Document Review Comment Sheet

PEB Ref. No : TB2-PEB-SDC-M1B-TVI-02734

PROJECT TITLE	THAI BINH2 THERMAL POWER PLANT 2 x 600MW
---------------	--

DRAWING TITLE	HP FEEDWATER HEATER #6 11LAD10AC006/21LAD10AC006 DETAIL OF NOZZLE (4/4)
---------------	---

FIG. UG-118 FORM OF STAMPING

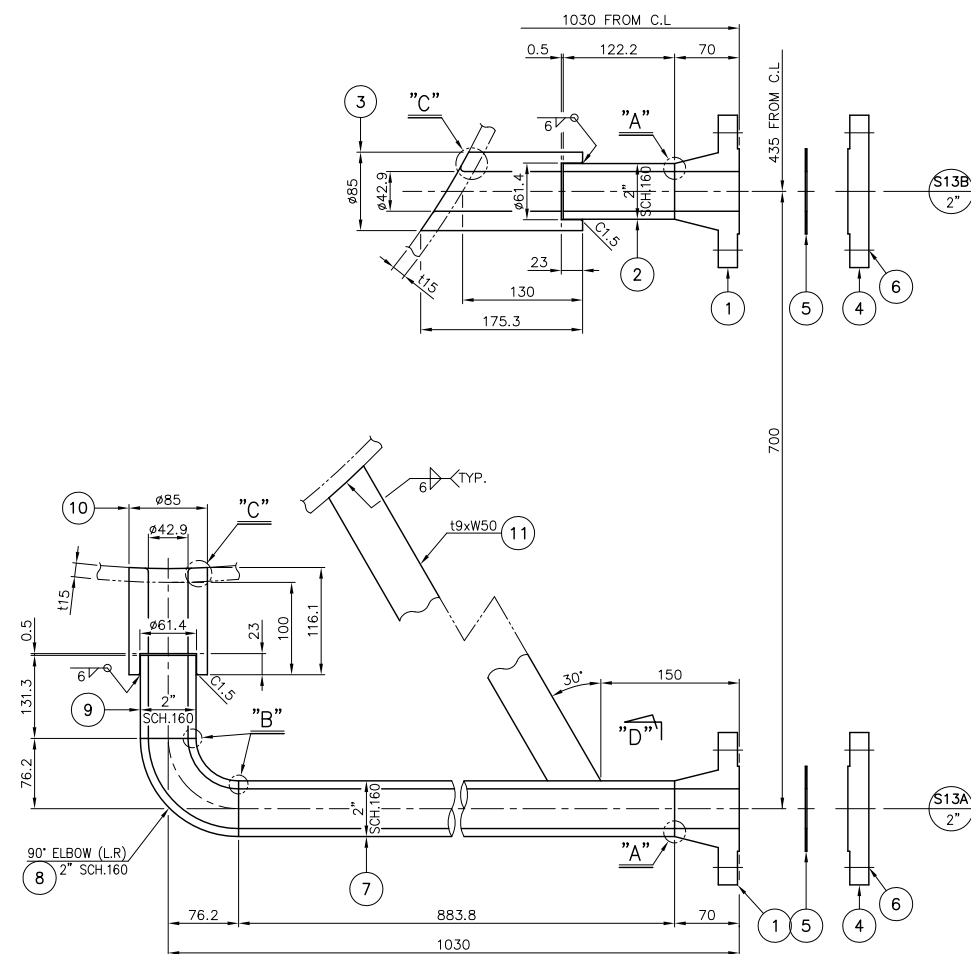
2	Please note that: Nameplates shall be in English with a minimum letter size of 6.4 mm.		ASME 'U'stamp project letter size was min 4mm.(UG-108). But we will used letter size 7mm.
